*Southern California Edison Company*

Subject: Docket No. 50-206  
NUREG-0737 Item II.D.1-Performance Testing of  
Relief and Safety Valves  
San Onofre Nuclear Generating Station  
Unit 1

RESPONSES TO NRC QUESTIONS ON  
PRESSURIZER RELIEF AND SAFETY VALVE TESTING  
SAN ONOFRE NUCLEAR GENERATING STATION  
UNIT 1

Feedline Rupture 250 gpm @ 15 min.

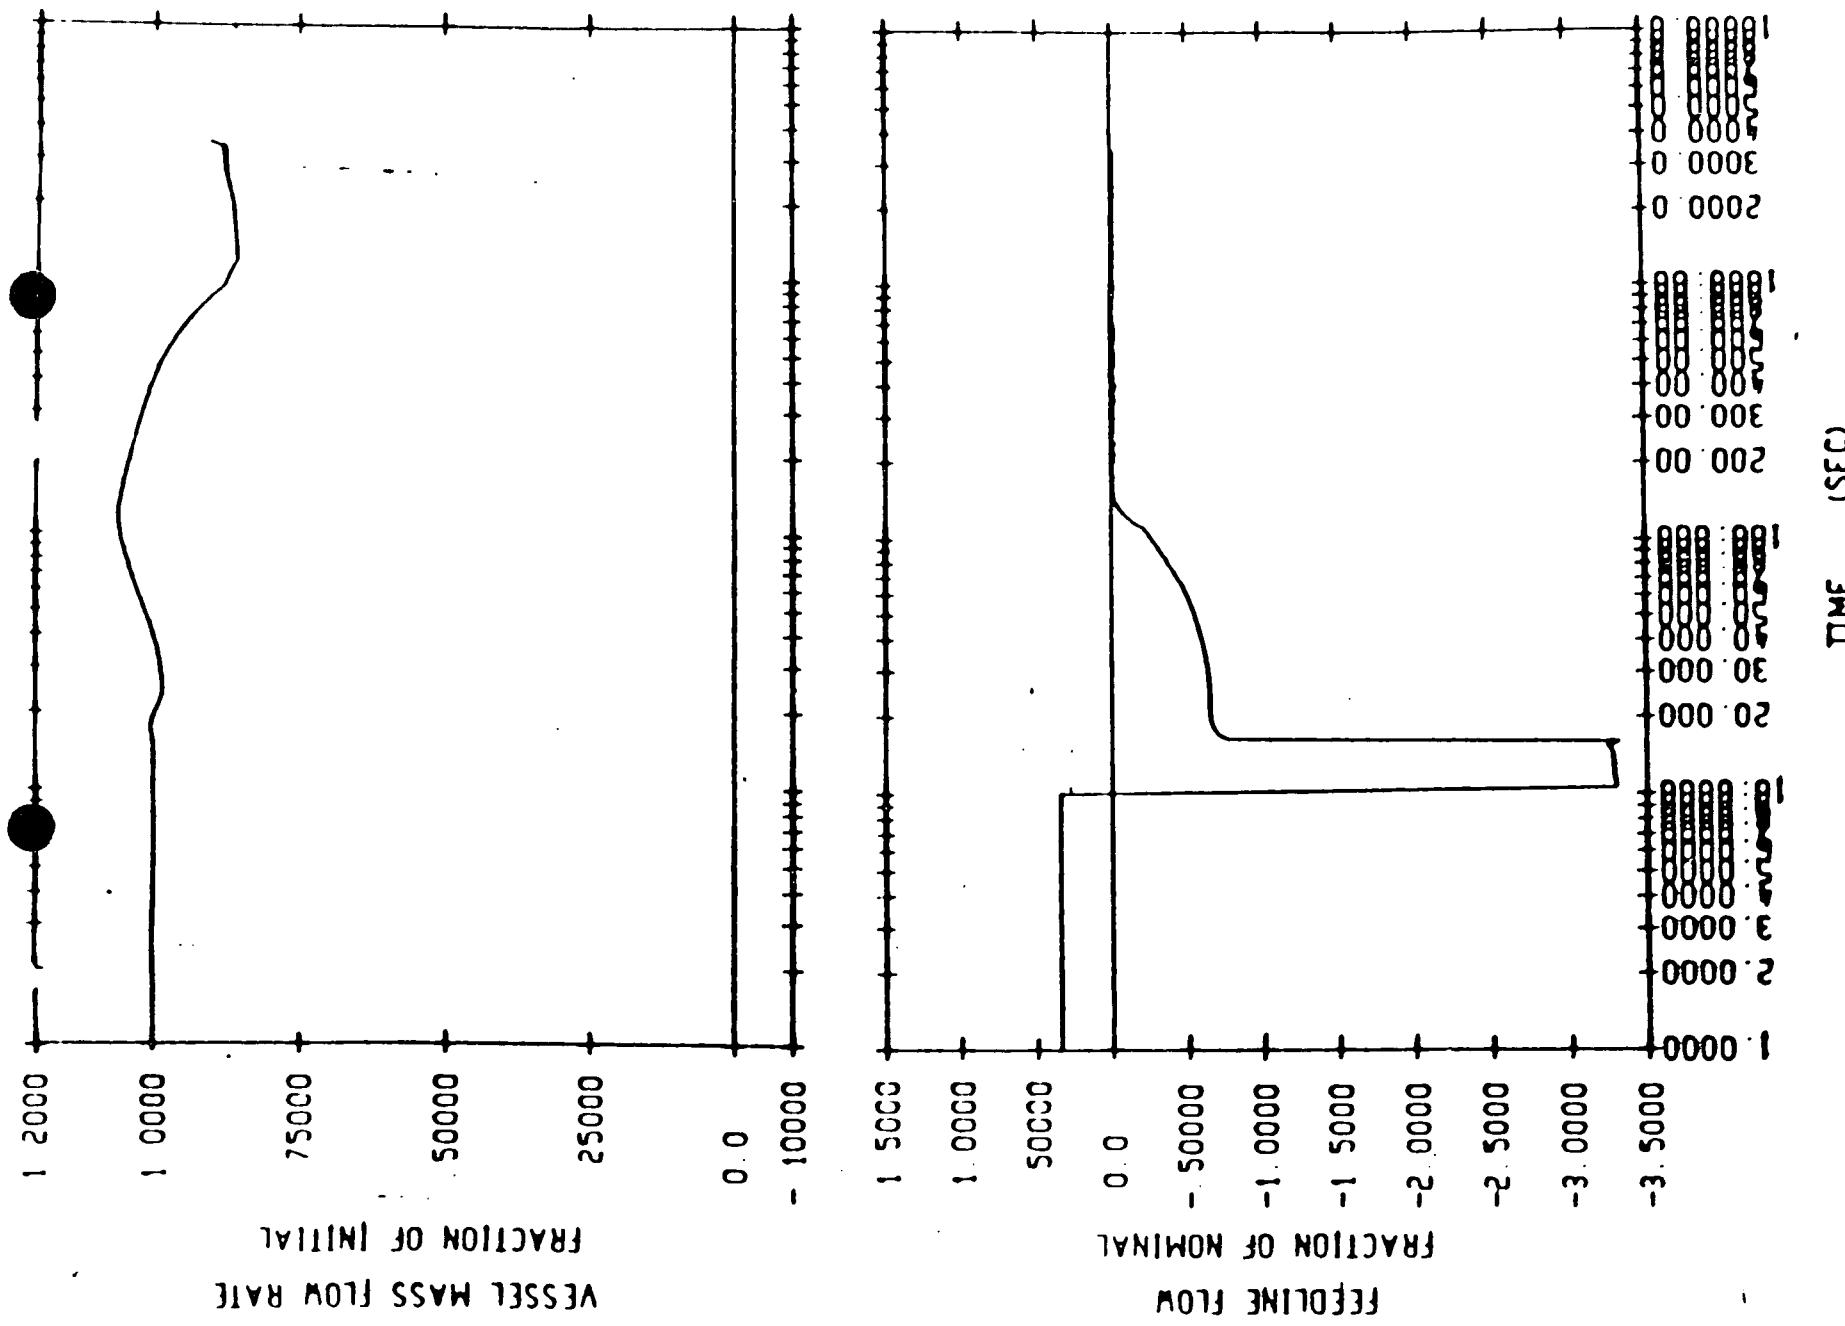
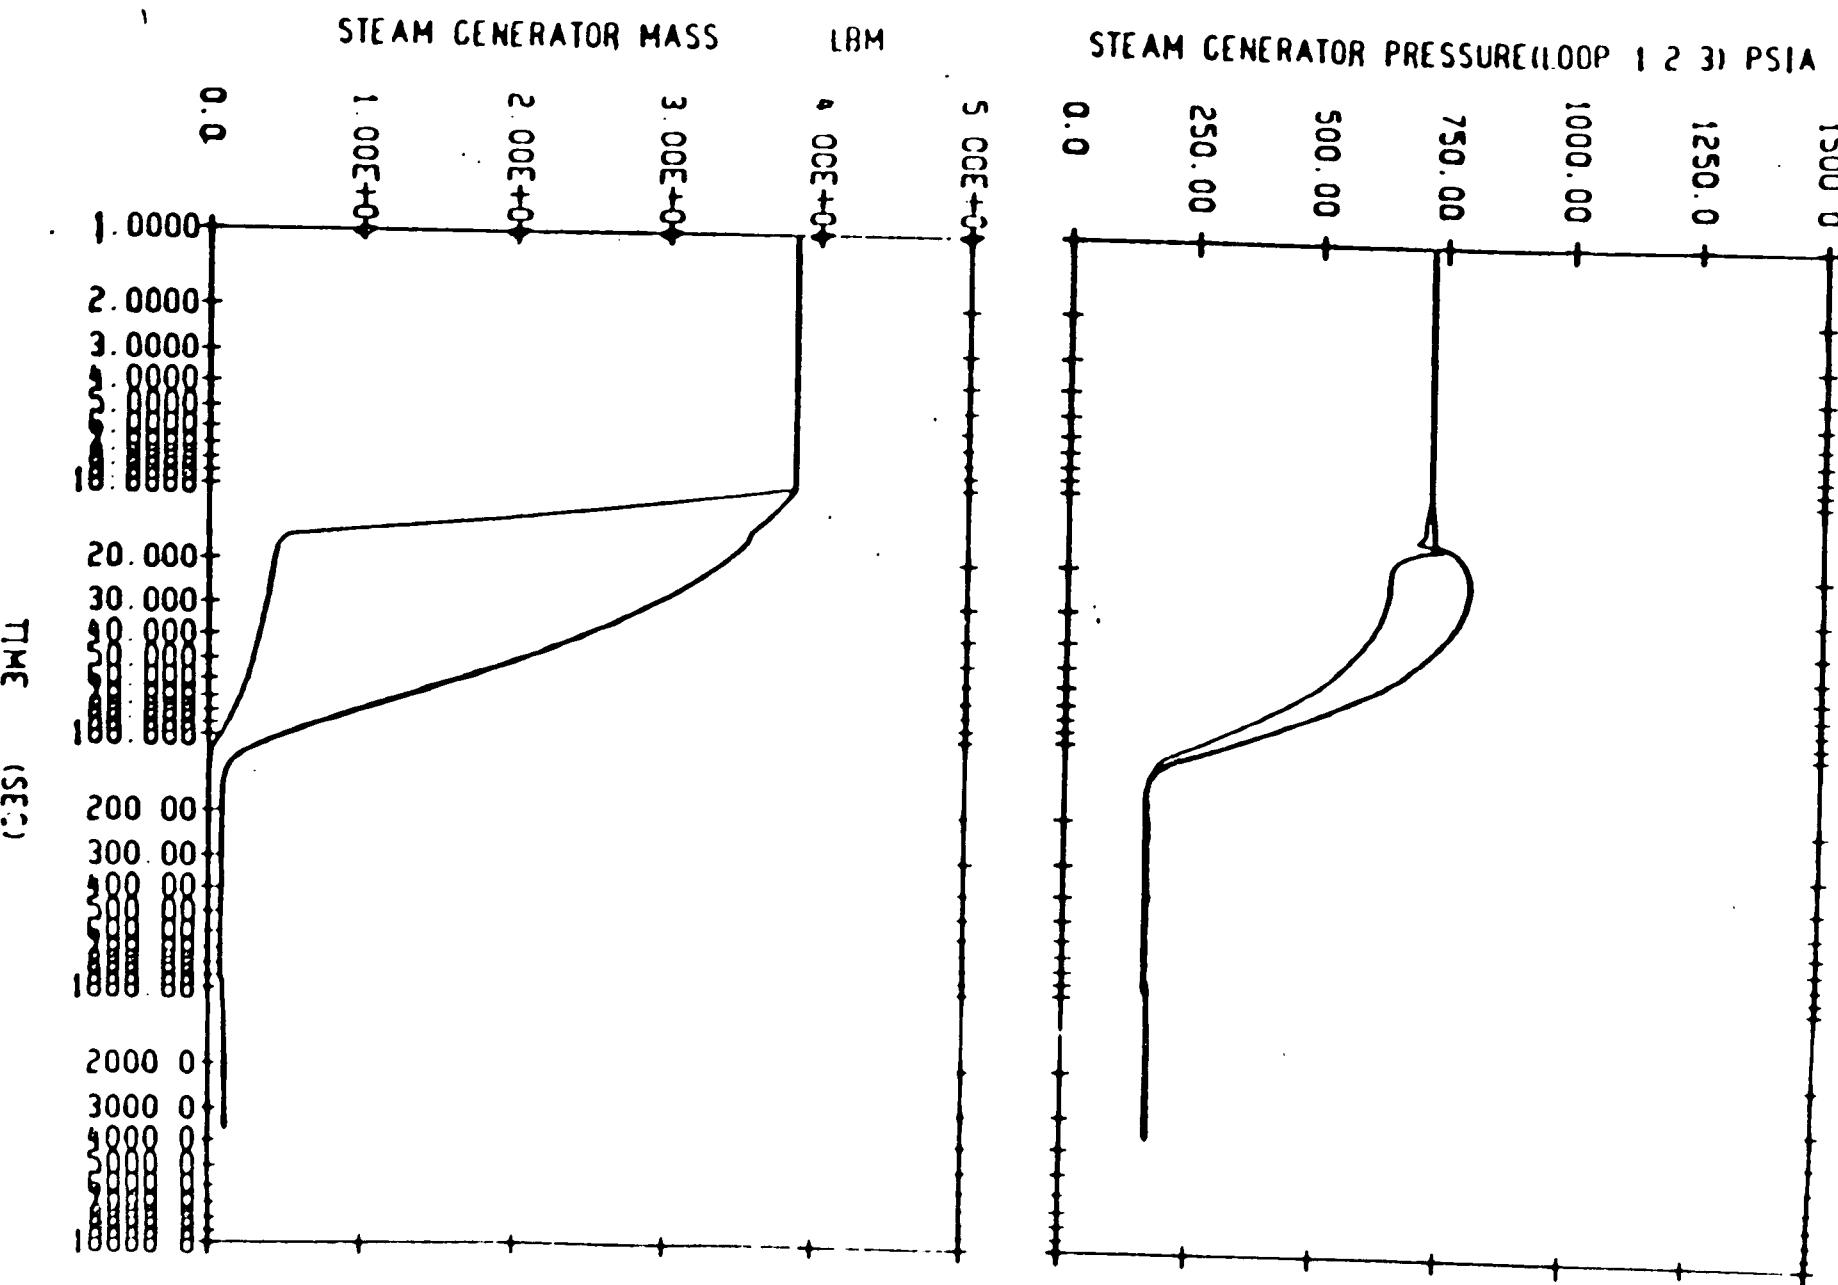
The Westinghouse valve inlet fluid conditions report stated that liquid discharge through both the safety and relief valves is predicted for an FSAR feedline break event. The Westinghouse report gave expected peak pressures and pressurization rates for some plants having an FSAR feedline break analysis. San Onofre 1 was not included in this list of plants having such an FSAR analysis. Nor does the submittal address the feedline break event. NUREG-0737, however, requires analysis of accidents and occurrences referenced in Regulatory Guide 1.70, Revision 2, and one of the accidents so required is the feedline break. Provide fluid pressure and pressurization rate, fluid temperature, valve flow rate, and the time duration for the feedline break event. Provide assurance that the valves passed water for a sufficient duration during the tests to cover this event and furnish an analysis which demonstrates safety of the safety/relief valve system for the feedline break event.

In response to post-TMI requirements, a feedline break analysis was performed and submitted to the NRC under the subject of Automatic Initiation of Auxiliary Feedwater Systems by letters dated March 6, 1981 and November 18, 1981. This analysis was reviewed and approved by the NRC as part of TMI Item No. II.E.1.1 and documented in NRC Amendment No. 65 dated October 2, 1982. The feedline break analysis was also reviewed and approved by the NRC as part of SEP Topic XV-6, Feedwater System Pipe Breaks Inside and Outside Containment (PWR), letter dated March 3, 1982 and XV-5, Loss of Normal Feedwater Flow, letter dated March 14, 1983.

The limiting feedline break analysis for San Onofre Unit 1 assumes auxiliary feedwater flowrate of 250 gpm and operator action time of 15 minutes after reactor trip. The appropriate plots of pressure, temperature and flowrates are attached. The defined "acceptable results" considered no bulk boiling in

the primary system prior to the time of loop temperature turnaround, i.e., the time when the heat removal rate equals the heat input on the primary side. Note that the peak pressurizer water volume is approximately 1299 cubic feet and the pressurizer capacity is 1300 cubic feet. Based upon these results, the limiting feedline break transient does not result in a solid pressurizer; thus, water relief is not predicted.
